RESISTANCES

Par suite de difficultés de fabrication, la galette SK 1 du 898 est modifiée. Le grain quadruple est remplacé par deux grains doubles. La paillette S22 est déplacée

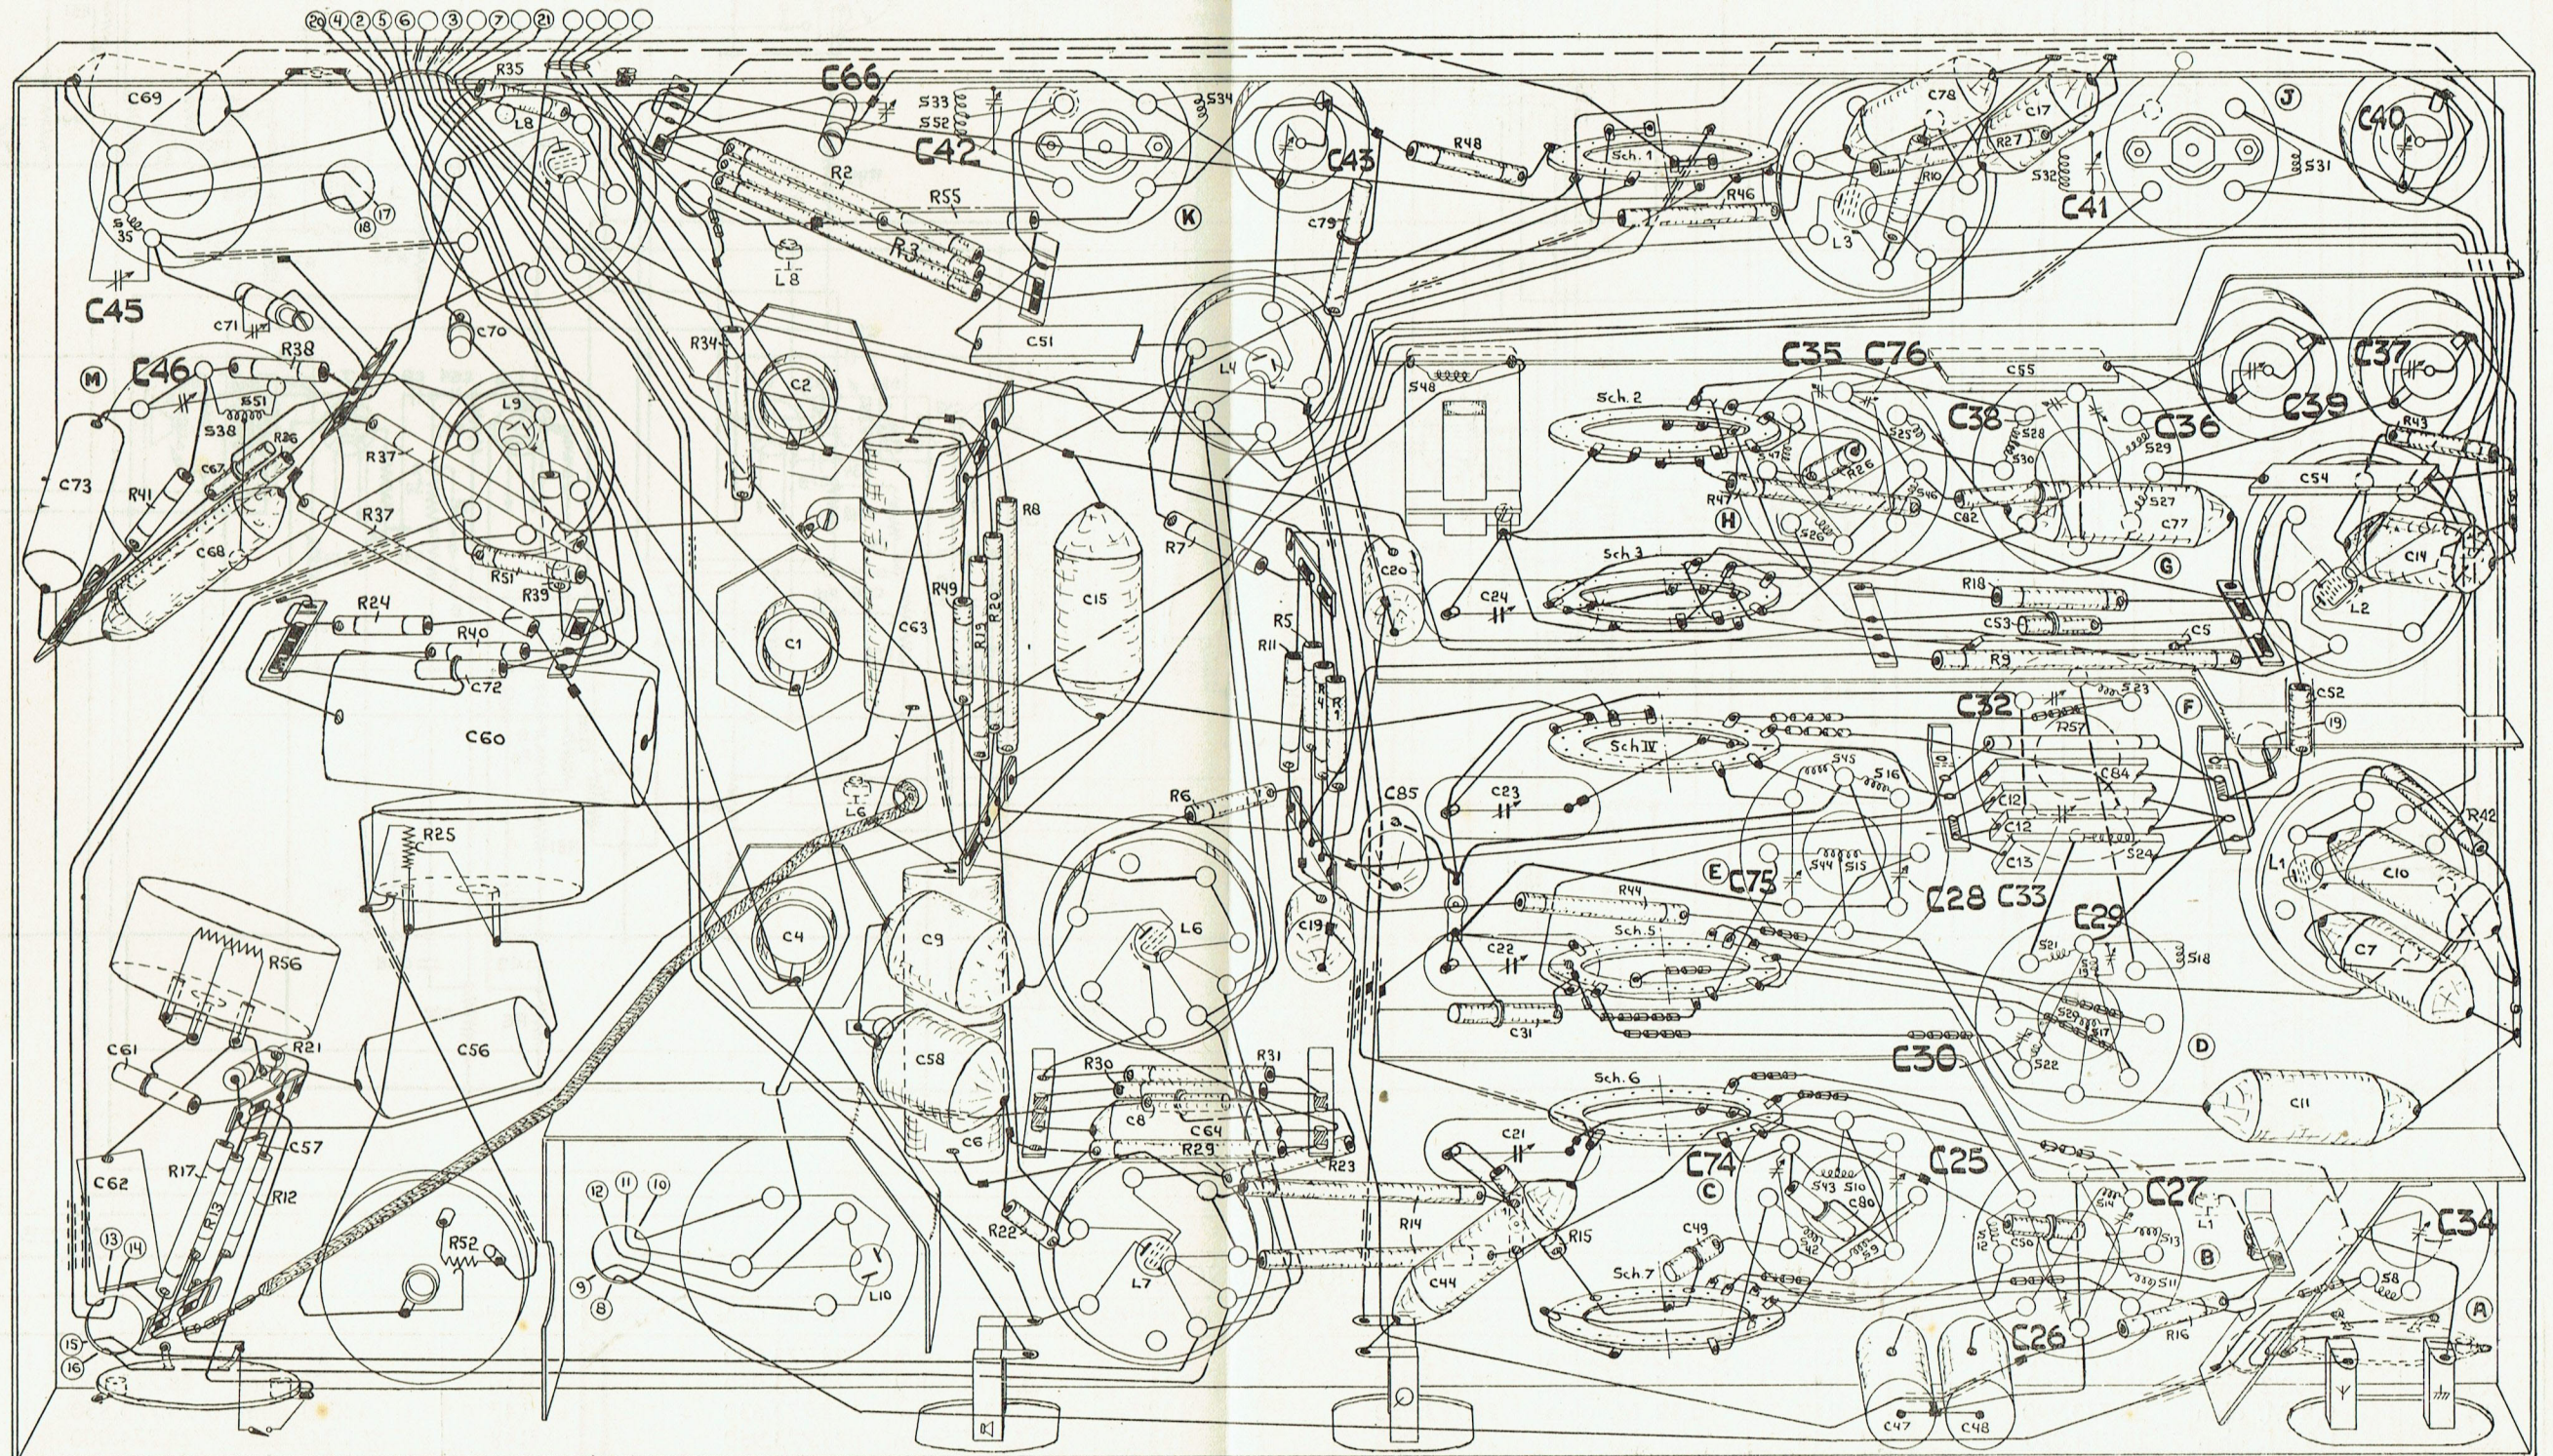
en 2. La connexion est reportée entre 20 et 2 et est livrée avec la nouvelle exécution, ce qui n'apporte aucune modification au câblage du châssis.
